# USB Type-C ENGINEERING CHANGE NOTICE

## Title: Clarification of USB4 Cable Speed for supported optional TBT3 Active Retimer Cables Applied to: USB Type-C Specification Release 2.3, Oct 2023

### (c). Section 5.4.3.2.3 Process for Discovering Thunderbolt 3 Cables

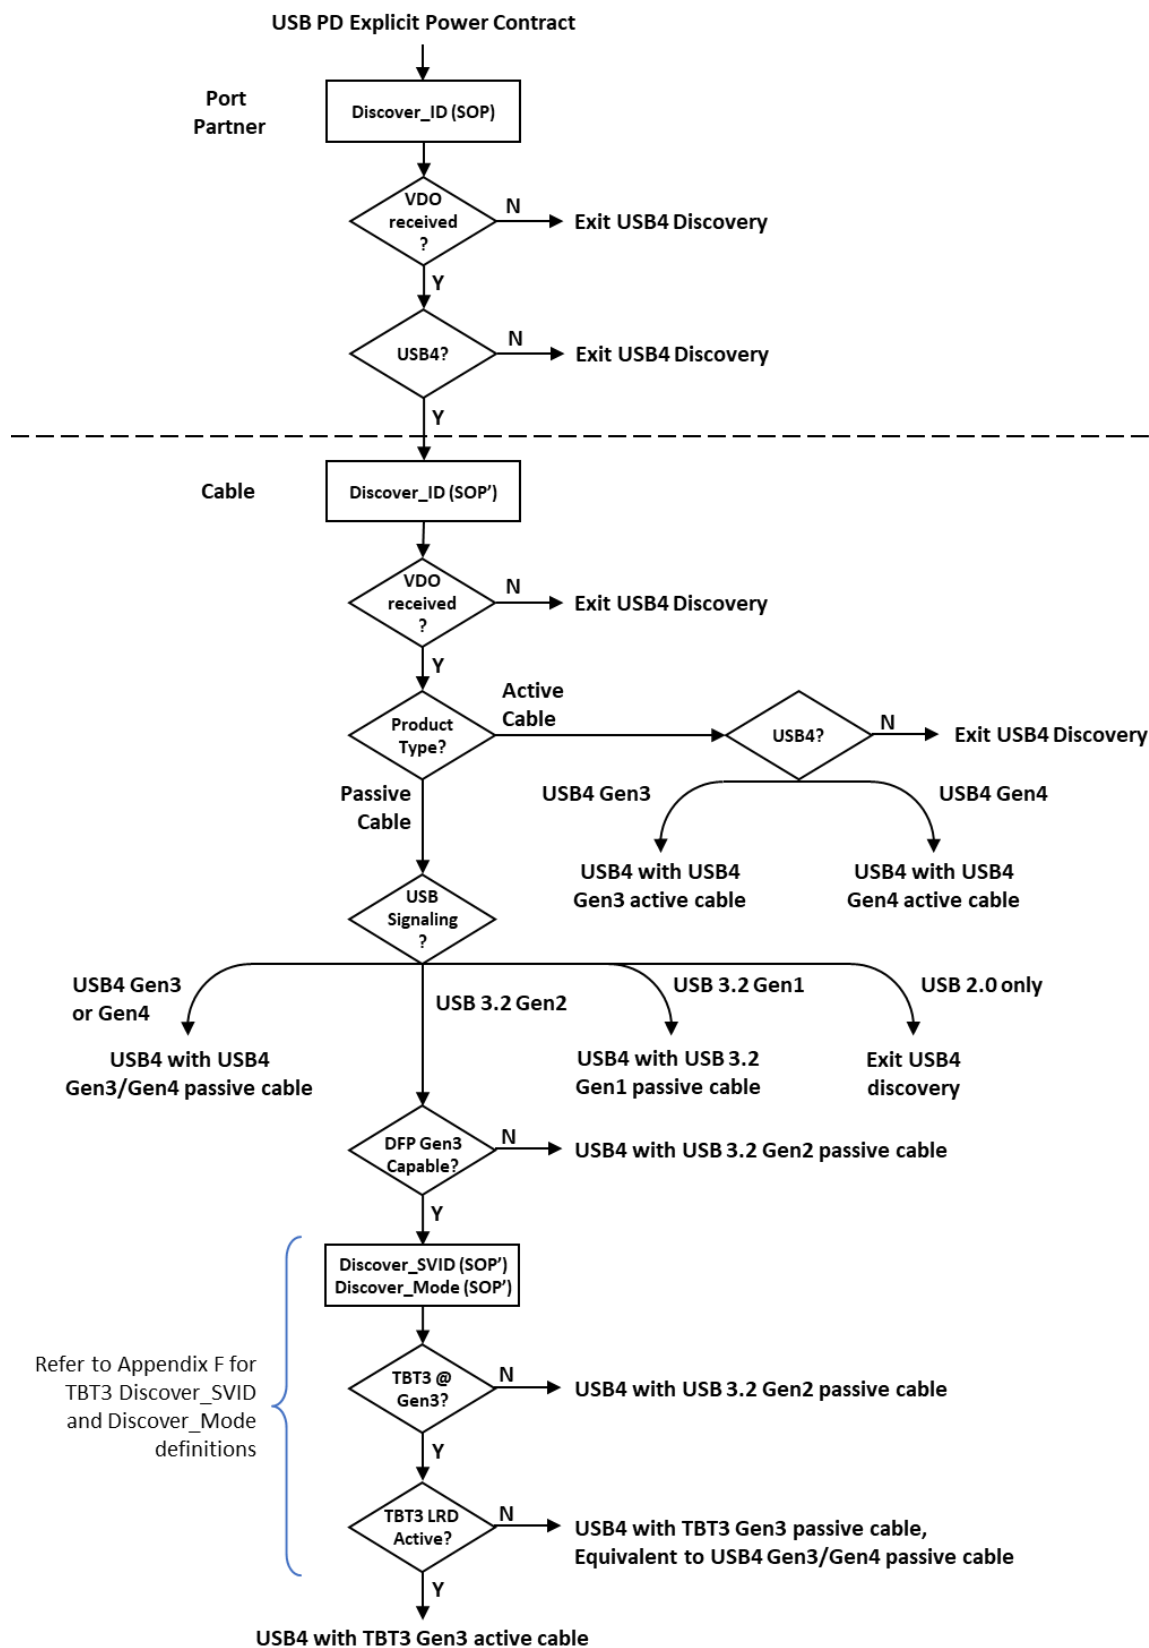
5. If this discovery is part of the USB4-compatible active cable discovery process, from the cable's Discover Modes VDO responses (see Section F.2.6), extract the value in the TBT\_Rounded\_Support Field **and extract the value in the Cable Speed field** to complete the process. [Note: discovery and use of USB4-compatible TBT3 active cables is an optional feature that also would require use of USB PD Enter Mode command to enable the cable for USB4 operation.].
